UNITED STATES  
NUCLEAR REGULATORY COMMISSION  
WASHINGTON, D. C. 20555

SUBJECT: QUESTIONS, POSITIONS AND REVIEW COMMENTS ON CONSUMERS  
APRIL 22, 1982 SUBMITTAL

Plant Name: Midland Plant, Units 1 and 2  
Licensing Stage: OL  
Responsible Branch: Licensing Branch #4, D. Hood, R. Hernan, LPM's  
Review Status: Continuing

Subject: Geotechnical Engineering Evaluation of Reference 1

**FIGURE BWST-5**

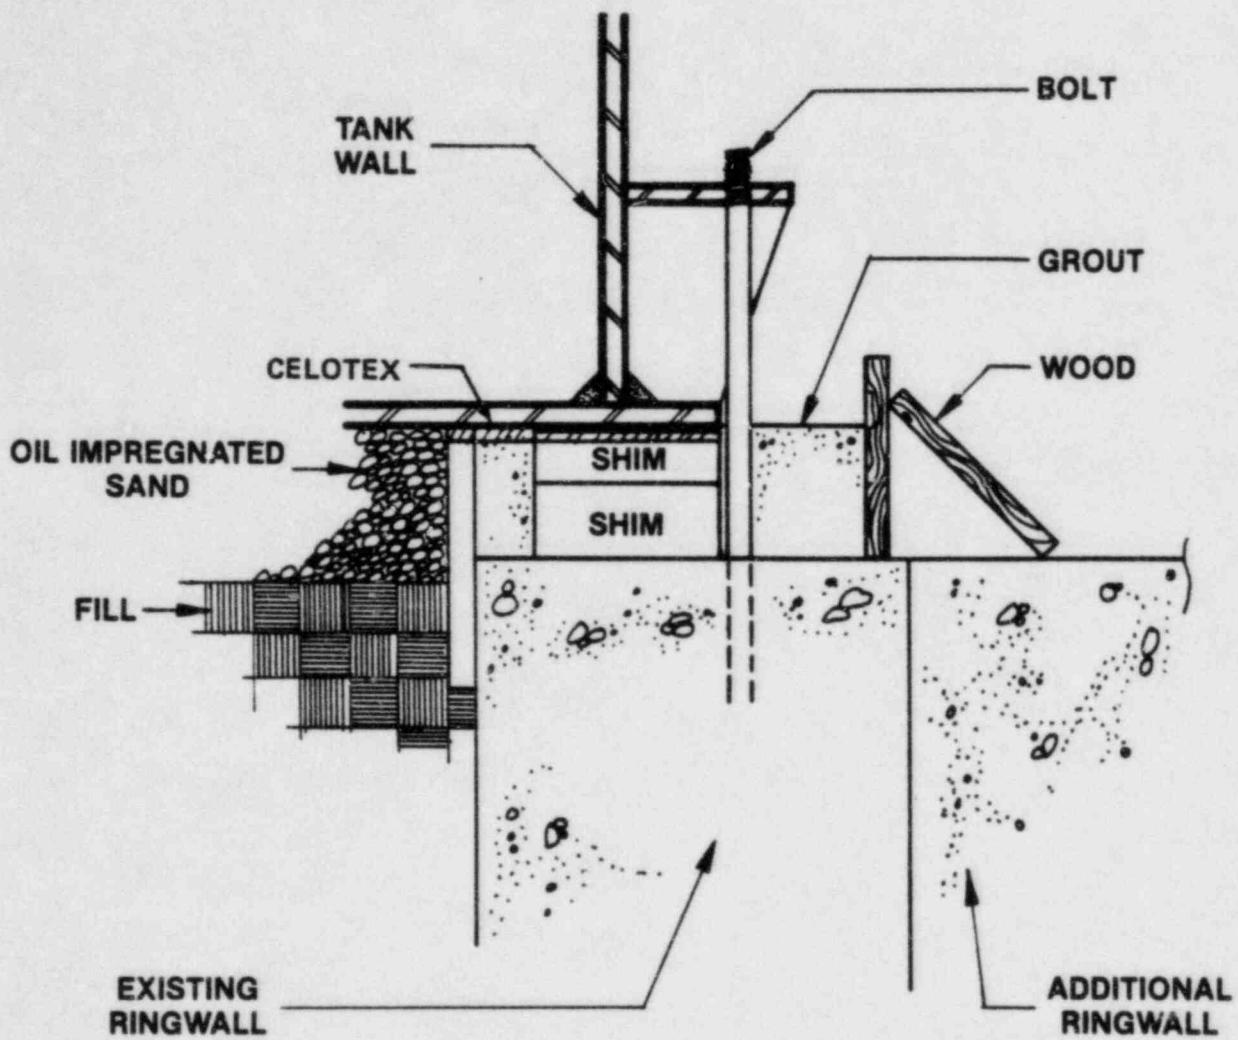
- Q.1. (Issue 1, Page 2, Par. 3) Provide the range in layer thicknesses that the oil-impregnated sand will be placed beneath BWST IT-60 tank and the construction controls to be required for its placement and compaction.

- Q.1. (Issue 1, Page 2, Par. 3) Provide the range in layer thicknesses that the oil-impregnated sand will be placed beneath BWST IT-60 tank and the construction controls to be required for its placement and compaction.
- Q.2. (Issue 2, Page 3, Par. 2) Averaging the strain over a 20-foot gage length is not acceptable to the Staff because this averaging could lead to underestimating stresses and unacceptable cracking. Installing shorter length gages ~~(maximum length of 5 feet)~~ over the 20-foot length is recommended. The Staff's concern with the single 20-foot gage length is further discussed in Q.5.

**FIGURE BWST-7**

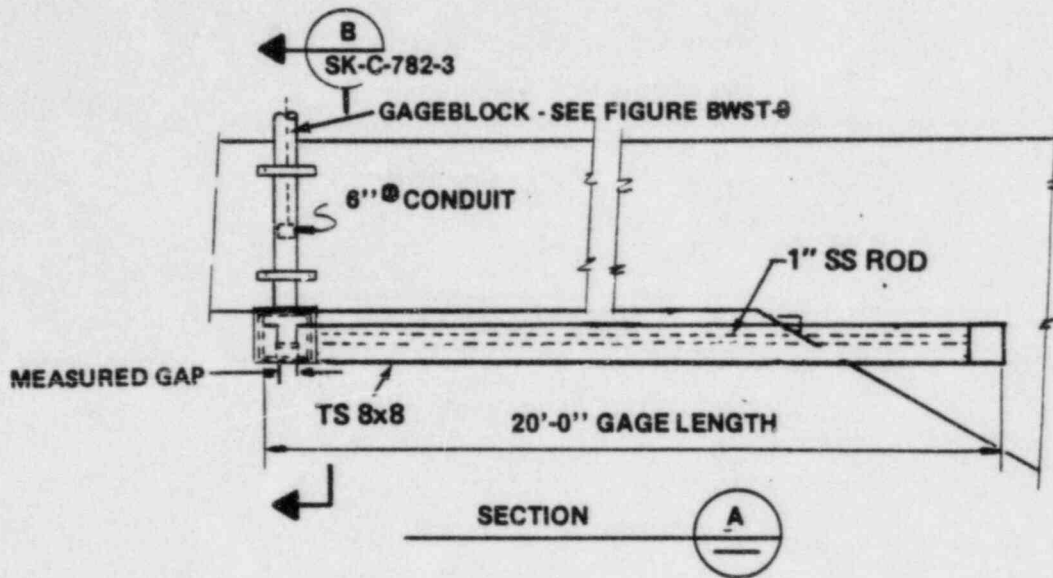
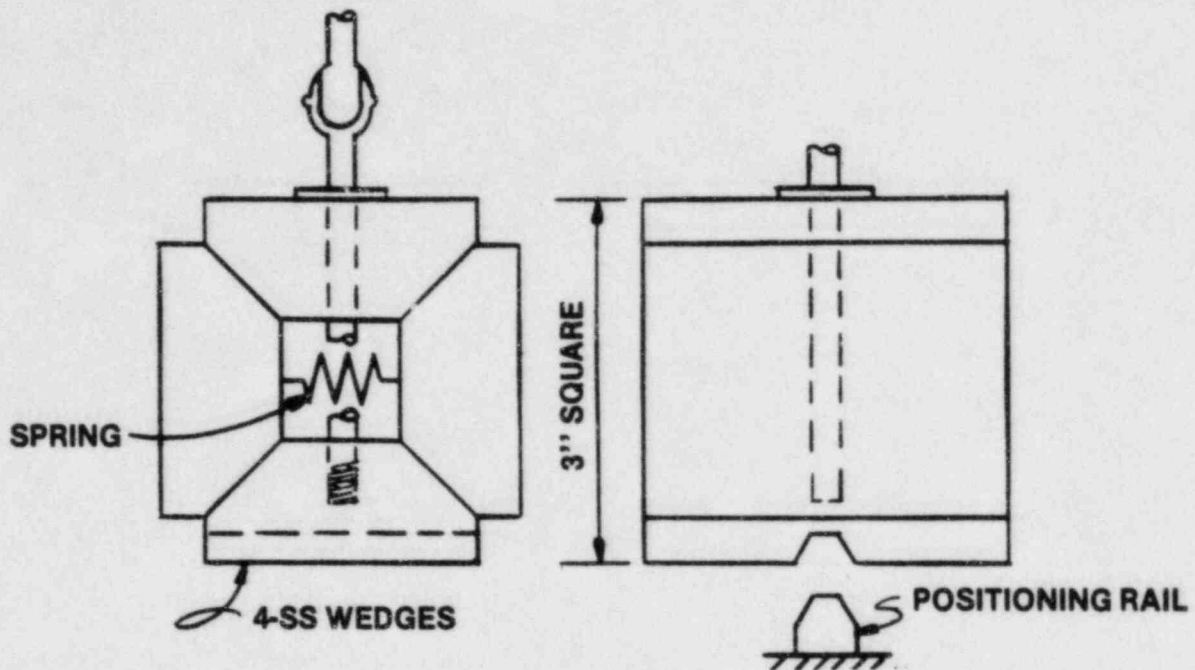
- Q.2 (Issue 2, Page 3, Par. 2) Averaging the strain over a 20-foot gage length is not acceptable to the Staff because this averaging could lead to underestimating stresses and unacceptable cracking. Installing shorter length gages over the 20-foot length is recommended. The Staff's concern with the single 20-foot gage length is further discussed in Q.5.

- Q.3 (Issue 2, Page 3, Par. 3) As a minimum, the BWST ring beams should be monitored for increasing strains at a frequency of at least once a year, following the initial 5 year period of plant operation.

Q.3. (Issue 2, Page 3, Par. 3) As a minimum, the BWST ring beams should be monitored for increasing strains at a frequency of at least once a year, following the initial 5 year period of plant operation.

**FIGURE SWPS-11**

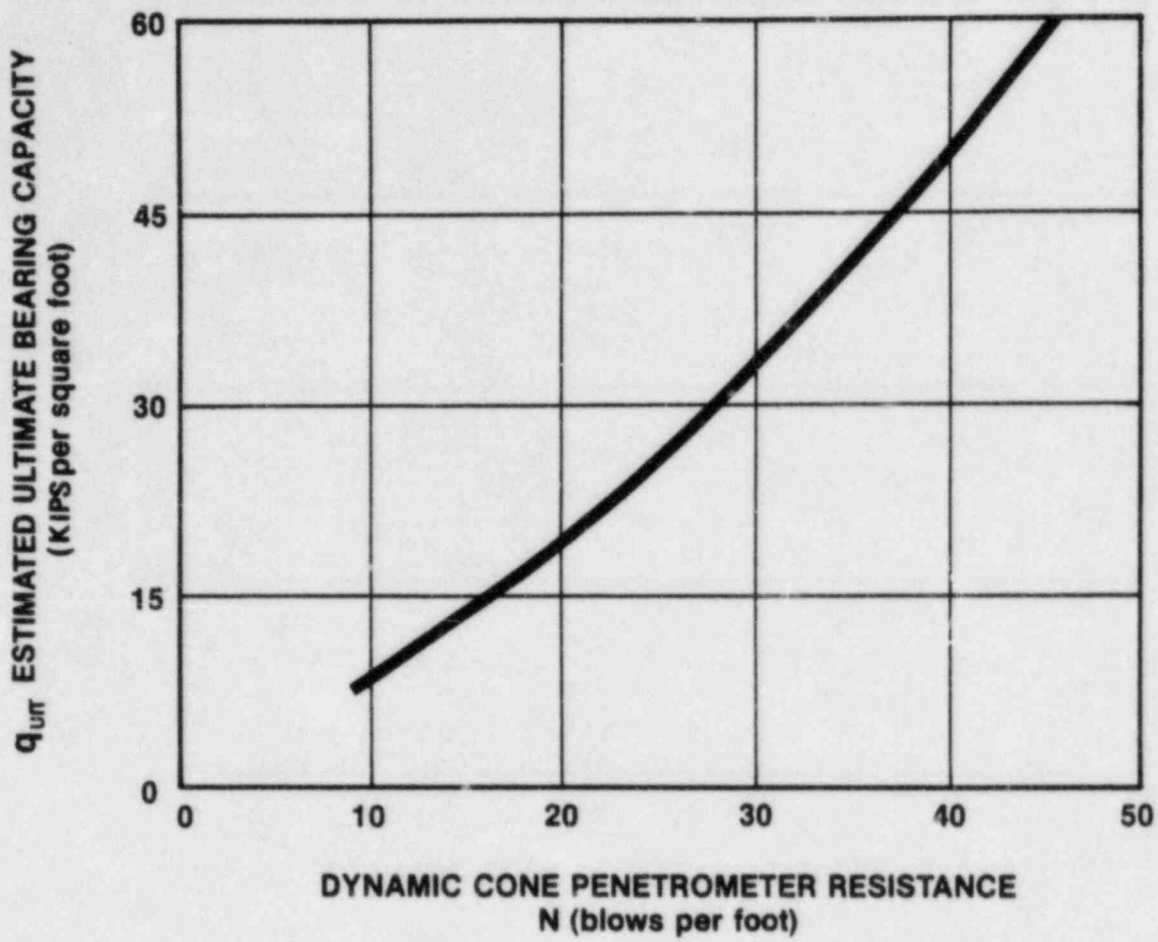
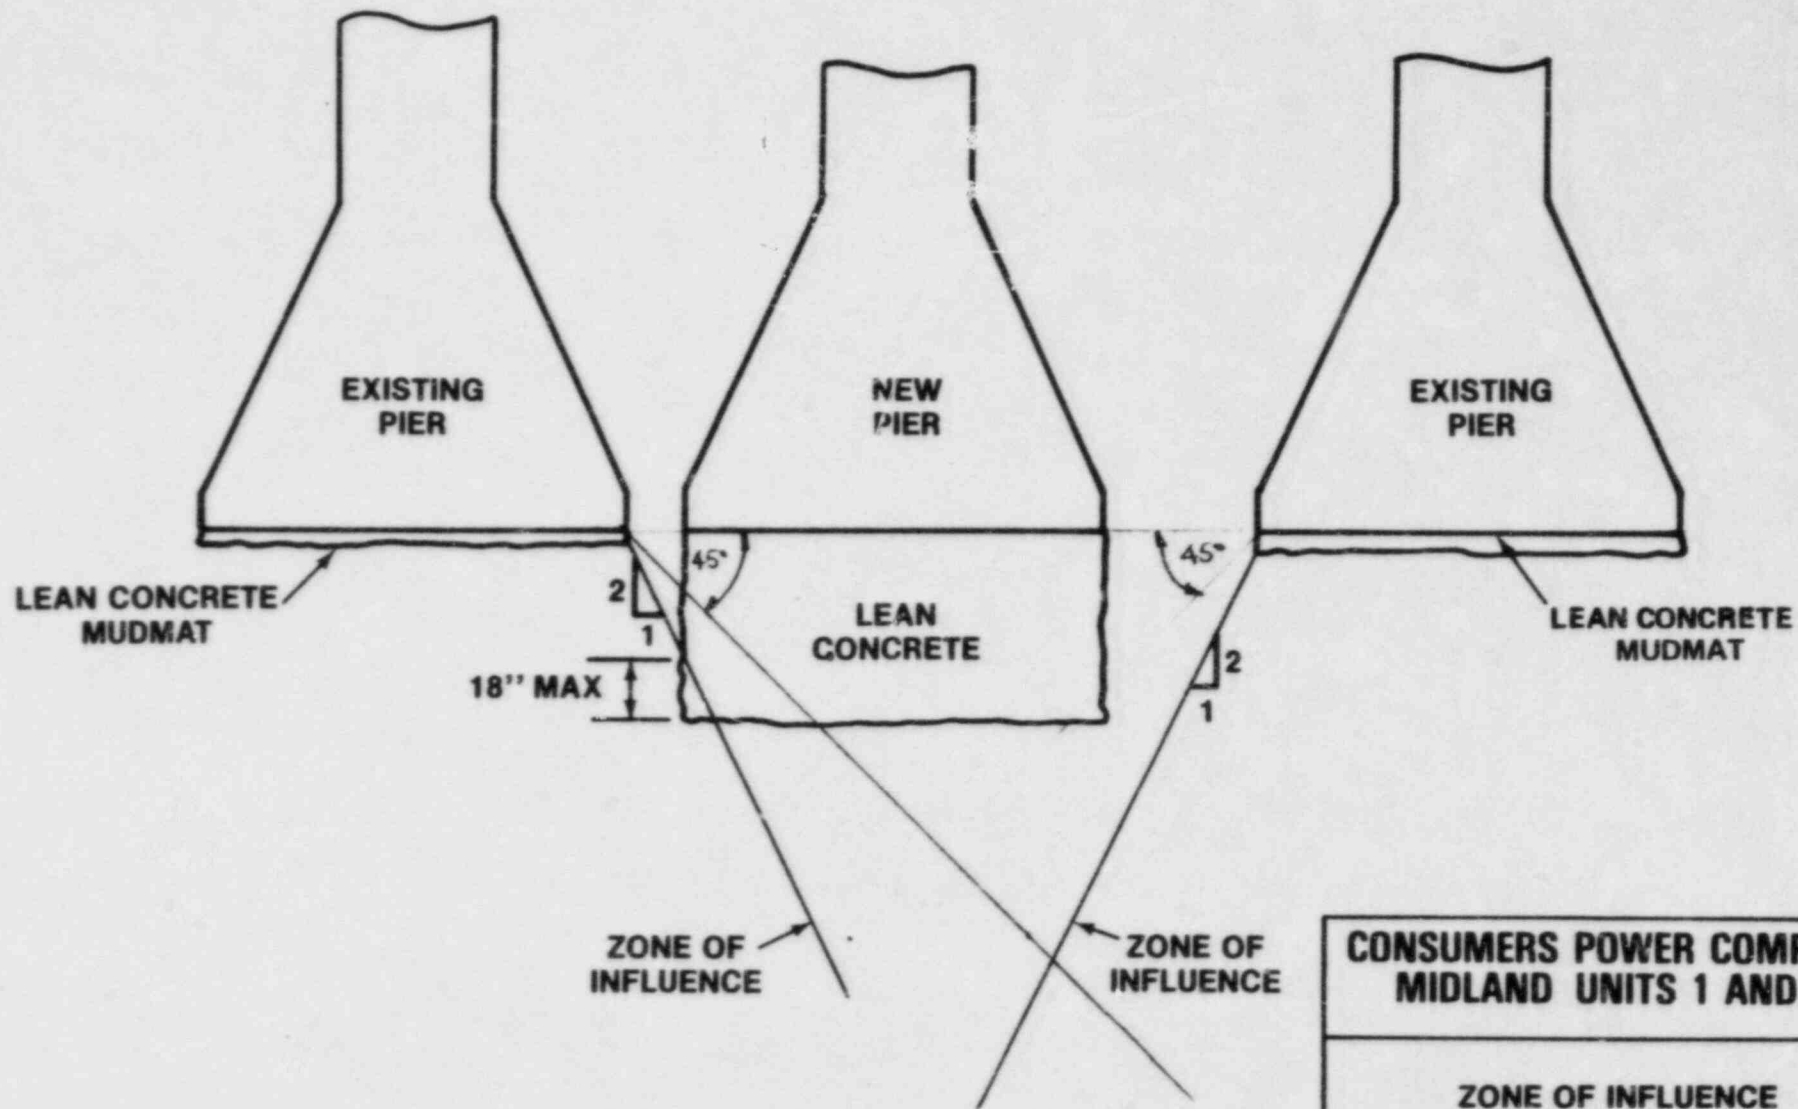
- a. On 5th line, Page 10, the word "solely" should be deleted.
- b. On 2nd line, Par. 3, Page 11, the word "generally" should be deleted. At the end of this paragraph add the following: The correlation between the pier or plate load test results and the penetration tests performed on the foundation soils will be used to correct the correlation graphs and to judge the suitability of the bearing stratum.

- b. On 2nd line, Par. 3, Page 11, the word "generally" should be deleted. At the end of this paragraph add the following: The correlation between the pier or plate load test results and the penetration tests performed on the foundation soils will be used to correct the correlation graphs and to judge the suitability of the bearing stratum.

- c. Last paragraph, Page 11, should be revised to incorporate the following changes. The zone of influence should be defined by extending lines downward at a slope of 1 horizontal (H) to 1 vertical (V) from the edge of the footing into the foundation soils. If the foundation soil is cohesionless, a <sup>braced</sup> braced excavation is required if the excavation must proceed more than 6-inches below the adjacent pier or, if not an immediately adjacent pier, then 6-inches below the intersection of the pier footing with the 1H to 1V zone of influence slope. Movements of adjacent piers shall be monitored as the excavation proceeds to 18-inches or less. Excavations shall be stopped and construction procedures modified if measured movements are larger than anticipated.

- c. Last paragraph, Page 11, should be revised to incorporate the following changes. The zone of influence should be defined by extending lines downward at a slope of 1 horizontal (H) to 1 vertical (V) from the edge of the footing into the foundation soils. If the foundation soil is cohesionless, a braced excavation is required if the excavation must proceed more than 6-inches below the adjacent pier or, if not an immediately adjacent pier, then 6-inches below the intersection of the pier footing with the 1H to 1V zone of influence slope. Movements of adjacent piers shall be monitored as the excavation proceeds to 18-inches or less. Excavations shall be stopped and construction procedures modified if measured movements are larger than anticipated.
